**Environmental  
Protection Agency**

August 4, 2011

RE: SUMMIT COUNTY  
VILLAGE OF BOSTON HEIGHTS  
PAYCHEX OFFICE BUILDING  
CONSTRUCTION STORM WATER

Figure 1 – The inlet protection on the storm drains should be modified.

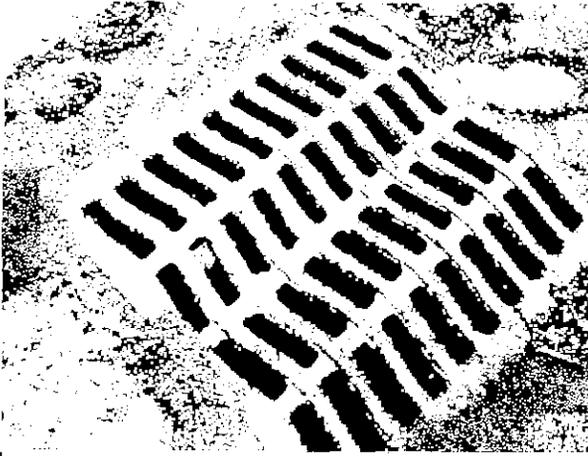
1. The inlet protection still has not been replaced (Figure 1). Please remove the geotextile fabric under the grate and replace it with a framed structure designed in accordance with the *Rainwater and Land Development Manual* (Ohio Department of Natural Resources, 2006), available on-line at <http://www.dnr.state.oh.us/tabid/9186/default.aspx>. You must also install an approved form of inlet protection, such as a Dandy Bag or Silt Sack, on the storm drain in the northeast corner of the parking lot.
